**Conway Planning Commission
Staff Report**

7:00pm • September 18, 2017 • 810 Parkway Avenue

C1 CHARLESTON PLACE PRELIMINARY SUBDIVISION

CONWAY CITY PLANNING DEPARTMENT REVIEW CHARLESTON PLACE SUBDIVISION PRELIMINARY PLAT SUBMITTED BY CENTRAL ARKANSAS PROFESSIONAL SURVEYING

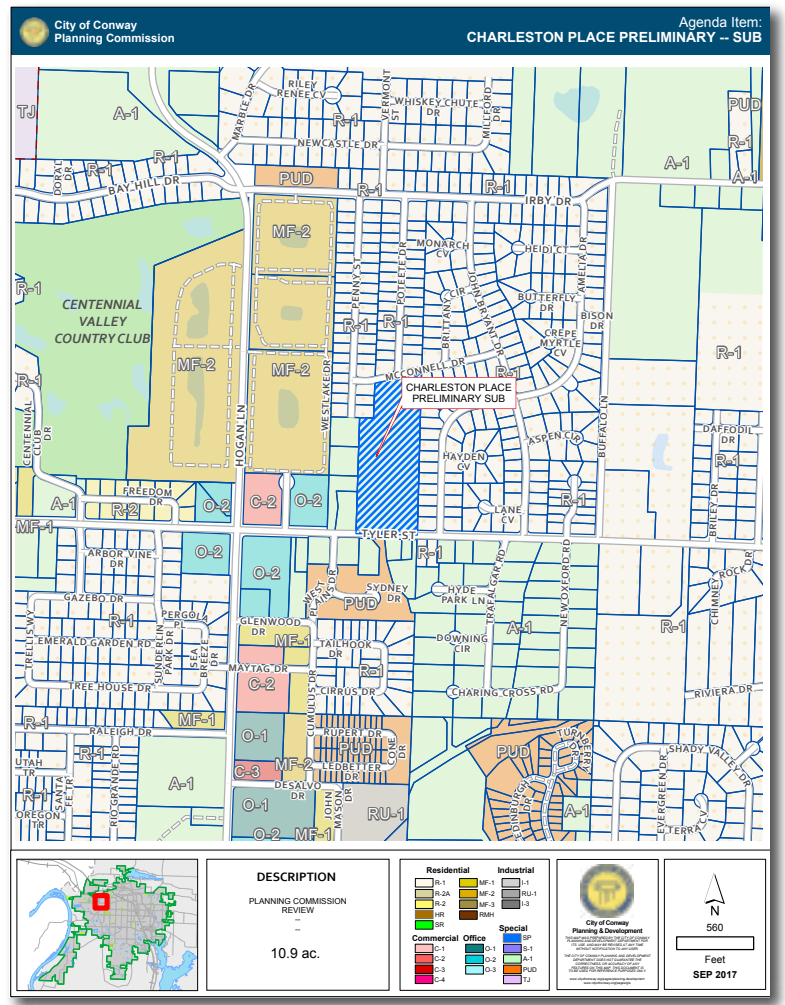
STAFF COMMENTS
Planning Commission action is required for items 11, 17, and 29.

- BASIC INFORMATION NEEDED ON THE PLAT**
- If any portion of the land being subdivided is subject to flooding, the limit of such flooding shall be noted and the appropriate 100 year floodplain and/or floodway shall be identified.
 - The present zoning classification of A-1 does not conform to the proposed subdivision or land use. The Preliminary Plat approval is conditioned upon rezoning from A-1 to R-1.
 - Proposed easements are needed.
 - A minimum of two CAGIS monuments shall be placed in each subdivision or subdivision phase exceeding ten (10) acres.
 - The Certificate of Preliminary Plat Approval is needed. Add "Anne Tucker, Chairman".

border of the property as a condition of preliminary plat approval. Planning Commission must require this land be reserved as a condition of preliminary plat approval and refer this Reservation to City Council, or this condition must be corrected.

- State Fire Code 503.0.5 states that dead-end fire apparatus access roads in excess of 150 feet in length shall be provided with an approved area for turning around fire apparatus. Anything other than the following cul-de-sac requirement must be approved by the Conway Fire Marshall. **Applicant requests approval of an alternative Hammerhead adjacent to lots 30/31 & 37/38, which meets AR Fire Prevention Code 2012 standards. Planning Commission must approve this request, or this condition must be corrected.**
- Preliminary Plat approval is conditional upon Street and Drainage Plan approval by City Engineer.

- Aside from the required sidewalks along collectors and arterials, an, internalized pedestrian circulation system in the form of pathways, either along streets or not, may be constructed within subdivisions upon the request of the applicant and the approval of the Planning commission. The system may be allowed to deviate from the construction requirements set out otherwise in this section, as long as the minion dimensional requirements are met. **Applicant requests to develop a pedestrian trail on the Western side of the subdivision in exchange for a reduction in required sidewalks along internal streets to lots just on the western side of Poteete Dr., the purpose to create a pedestrian loop within the subdivision. Planning Commission must approve this substitution or internal sidewalks must be added.**

STAFF RECOMMENDATIONS
 Staff recommends the approval of the preliminary plat subject to the completed punch list.

Preliminary Plat

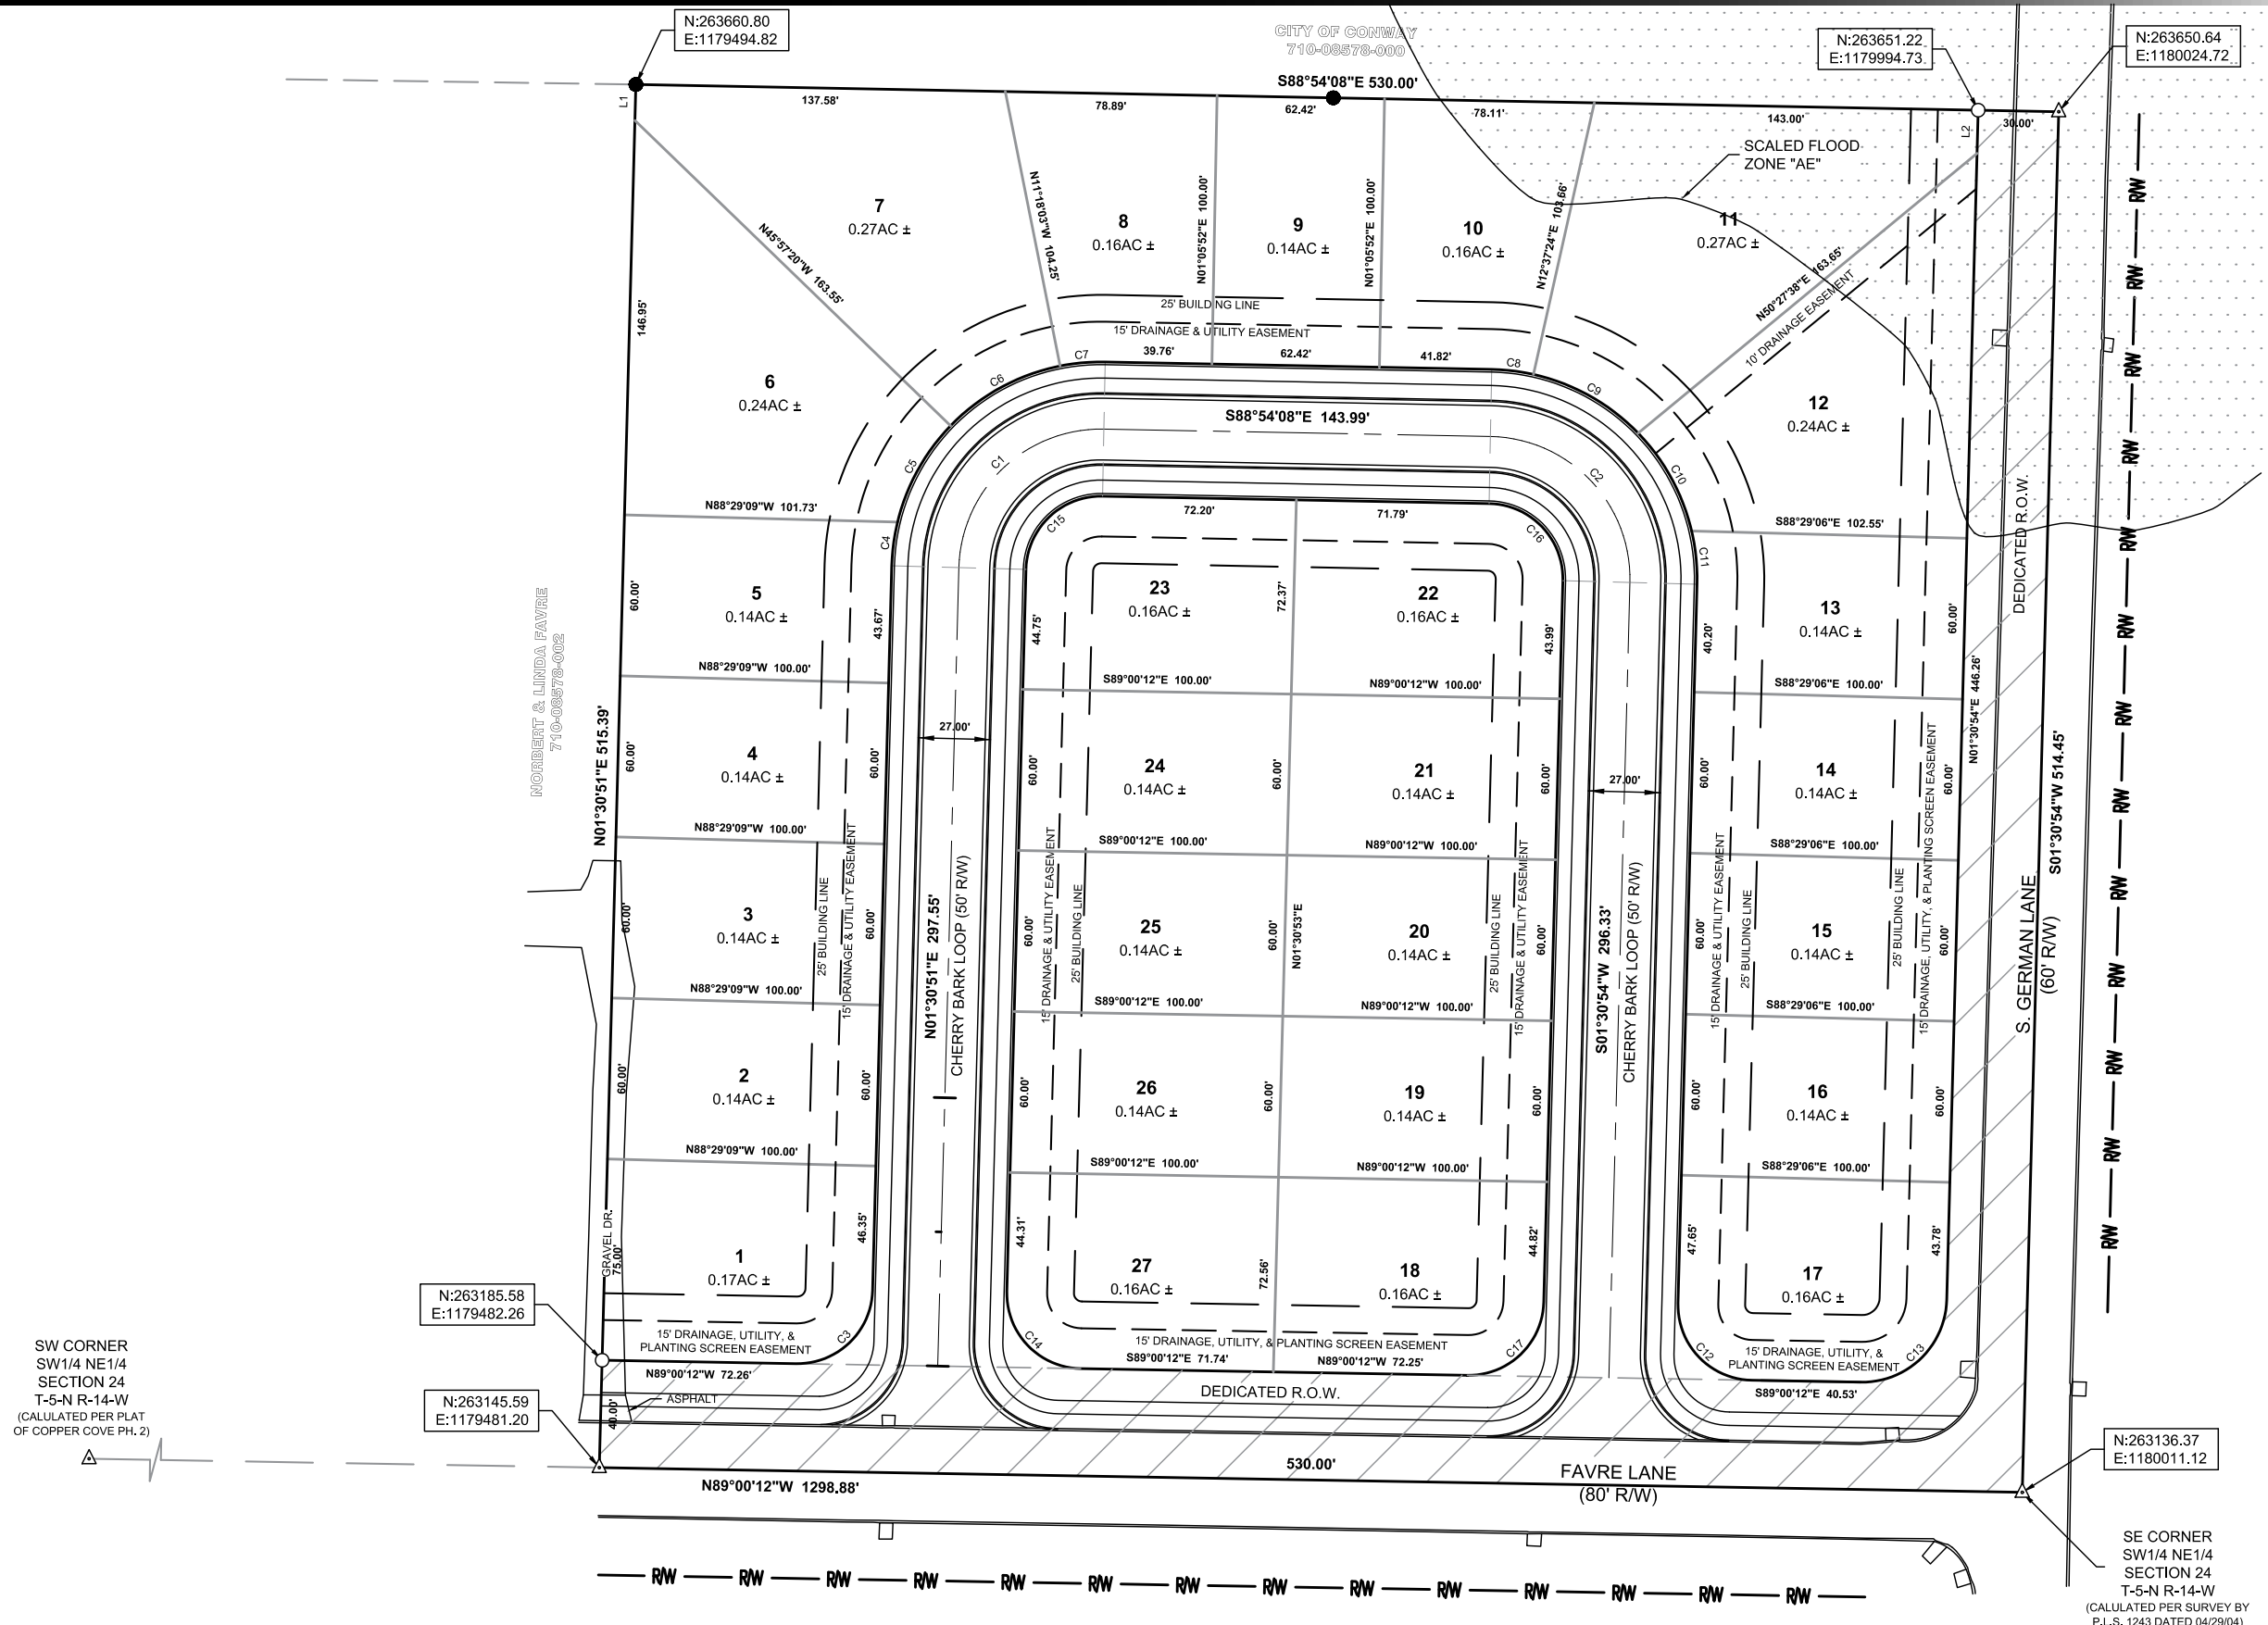
- A legal description of the property with exact boundary lines, bearings and distances is needed. Legal Coordinates do not match Boundary Coordinates
- If any portion of the land being subdivided is subject to flooding, the limit of such flooding shall be noted and the appropriate 100 year floodplain and/or floodway shall be identified.

- The present zoning classification of A-1 is inappropriate for the proposed subdivision. Preliminary Plat approval is conditioned upon the current zone being changed from A-1 to R-1.

9. An easement of adequate width to accommodate the required floodway shall be provided on the plat. The easement shall clearly identify the easement as a "100-year Floodway". The plat shall have a note that reads as follows: "No structures, fill or obstructions shall be placed in the 100 year Floodway easement. No reshaping of the surface within the 100 year Floodway easement shall be made without the approval of the City Engineer. No fences shall be in the floodway easement."
10. Minimum floor elevations shall be placed on the plat for all lots less than three (3) feet above the computed one hundred (100) year flood elevation. The minimum finished flood elevation shall be established at one (1) foot above the computed one hundred (100) year flood elevation. Lots 7 thru 17 should have minimum floor elevations notated on the plat.

11. Utility easements as required by Conway Corporation are needed.
12. Drainage easements as required by the City Engineer are needed.
13. Where possible, pedestrian trail and pathway systems shall link open space corridors through major utility, drainage and other easements and another easement for the pathways shall be established within that easement. **Pedestrian Pathway strongly recommended along the 15' Drainage Easement to the northeast for connection to existing City park space.**

14. Minimum lot width must conform with the requirements of the Zoning Ordinance. Lots 27 & 18 require 75' lot width for corner lots. Preliminary Plat approval is conditional upon developer seeking a variance for reduced lot width by board of zoning adjustments or these conditions must be corrected.
15. Double frontage lots other than corner lots fronting on two streets shall not be platted except under extreme circumstances, as may be approved by the **Planning Commission. The Planning Commission must approve lots 12-18 as double frontage lot or this condition must be corrected.**
16. Building lines shall be established for both front and rear lot lines for double frontage lots.

21. When a developer created double frontage lots with one side along a street classified as a collector or above, the developer shall construct sidewalks along the collector or greater street frontage. Sidewalks along S. German Lane and Favre Lane are required and responsibility of developer. Sidewalks should be shown along S. German Lane.

Staff recommends the approval of the preliminary plat subject to the completed punch list.
